Westview Acres Concept Plan Amendment
DV-CONCEPT PLAN 23-00020: Submittal 3 Cover Letter

This is to request an amendment to the Westview Acres Concept Plan and Annexation Agreement approved upon the annexation of the property into the City of Longmont on December 20 2022. The amendment will increase the number of lots from twenty-two (22) to twenty-four (24) on the 6.83 acres; increasing the density .28du/ac from 3.22du/ac to 3.5du/ac (8%).

Amended Concept Plan – 24 Lots, removal of existing homes

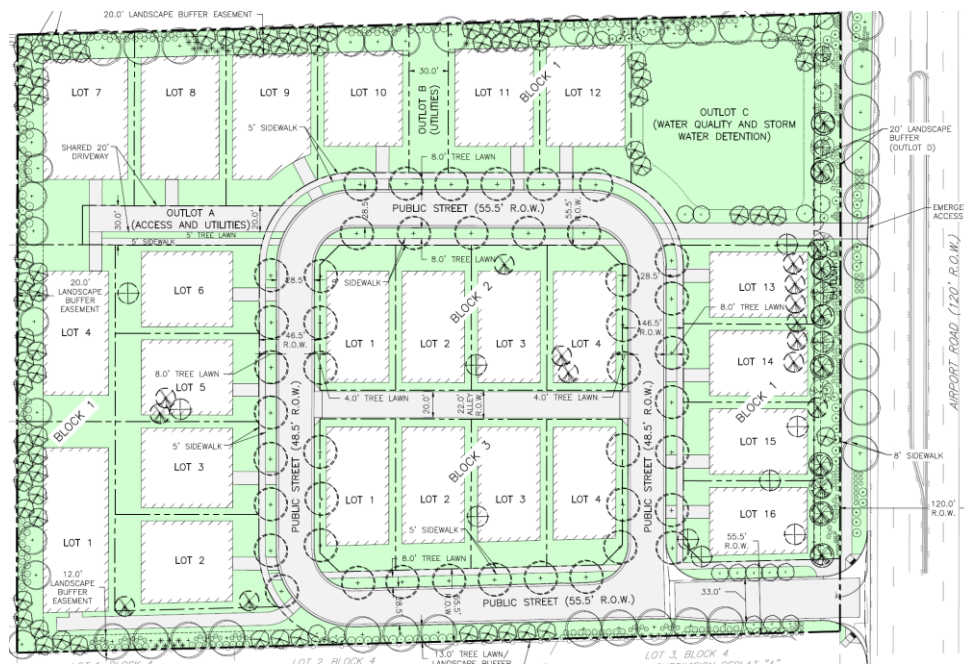
Concept Plan Amendment. Westview Acres was annexed into the City of Longmont with a Concept Plan approved with twenty-two (22) lots on the 6.83ac property. The Concept Plan has been amended to twenty-four (24) lots to enhance its sustainability; allow for the removal of the existing houses; while maintaining the same buffer and reducing the number of lots along the north property line. The Amended Concept Plan was presented to the neighborhood at a meeting on April 25 2023 and received a positive response because of the removal of the existing homes and reduction of the number of lots on the north property line. The amended Concept Plan has been submitted concurrently with a Preliminary Plat which reflects the 24-lot plan.

The general lotting pattern will remain the same - arrayed on an internal street loop which includes a tree lawn. The looping internal street system also remains the same - consisting of 55.5' and 46.5' rights of way with double sided treelawns and parking on the E-W segments and single sided treelawns and parking on the N-S segments. There are no access points to adjacent neighborhoods. The project will conform to the R-SF standards and the intent is to develop the project in one construction phase.
